Subject: William States Lee III Nuclear Station  
Public Notice No.: 2009-122-SIR  
Request for Additional Information

**Duke Energy Response to SCDHEC**  
**401 Request for Additional Information**  
**August 30, 2012**

**SCDHEC 401 Request for Information (Letter to Robert Wylie from Alicia Rowe) Letter Dated: May 24, 2012**

**Figure 1: Pond C Frequency Storm Discharge Comparison under Existing and Proposed (with Pond C) Conditions.**

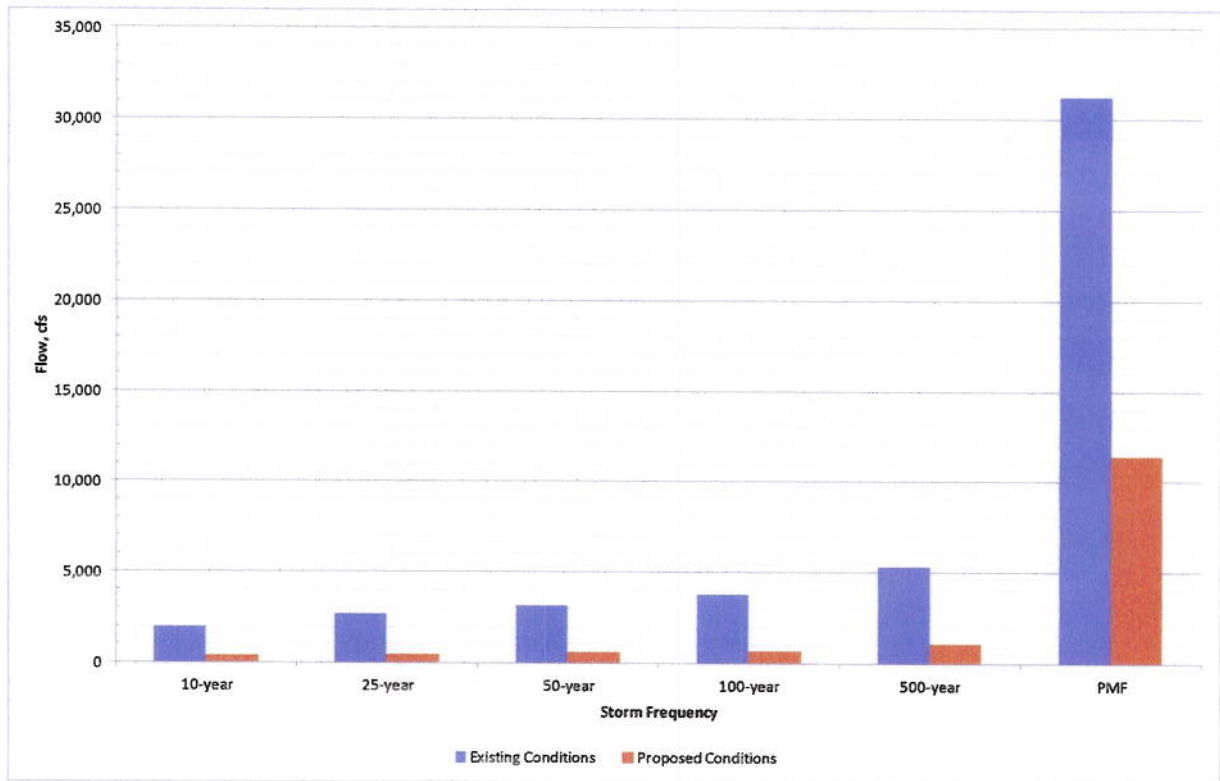
During major flood events in London Creek and Lake Cherokee, the peak flow will be significantly faster and higher in magnitude because of the lake water body in

London Creek. The flood impact on Broad River may not be very significant because the size difference of the drainage area between London Creek and Broad River. However, the flood impact of London Creek will be very significant on property and personnel in the drainage area between Broad River and the proposed dam on London Creek. Flood zone volume should be considered in the design of London Creek dam to catch and store the flood volume and release it downstream in non-flood magnitudes. Releases from the Ninety-Nine Islands Hydroelectric Project should be synchronized with the flood from London Creek to minimize its impact on the Broad River.

Hydrologic/hydraulic modeling of London Creek with the proposed Pond C demonstrates that peak flow will not be faster or higher in magnitude during major flood events. Rather, modeling results show that Pond C would serve as a detention structure that has the ability to store and discharge peak flood waters at significantly lower peak flows than if the reservoir was not constructed. The combination of storage and discharge over the spillway structure would tend to reduce the magnitude of peak flows in London Creek below Pond C and discharging in the Broad River. Proposed operating conditions at Pond C are expected to decrease the peak Pond C basin discharge during the inflow design flood (IDF) (the probable maximum precipitation for the 3.88 sq mi basin) from approximately 31,184 cfs (without Pond C) to 11,360 cfs (peak discharge during the IDF from the proposed spillway).

A comparison of the London Creek basin discharges for the existing and proposed Pond C conditions is provided below in Table 1 and Figure 1. This table provides an assessment of Pond C basin discharge in terms of an equivalent return period on the Broad River below the Ninety-Nine Islands Reservoir. Return period information was calculated based on the synthesized hydrologic data developed during the LNS permitting and design process. The hydrologic data is based on the USGS 02153500 stream gauge located on the Broad River near Gaffney, SC along with two USGS stream gauges, USGS 02153200 Broad River near Blacksburg, SC and USGS 02151500 Broad River near Boiling Springs, NC, used to supplement missing data. The synthesized hydrology set was then prorated to the drainage area of the Ninety-Nine Islands Reservoir.
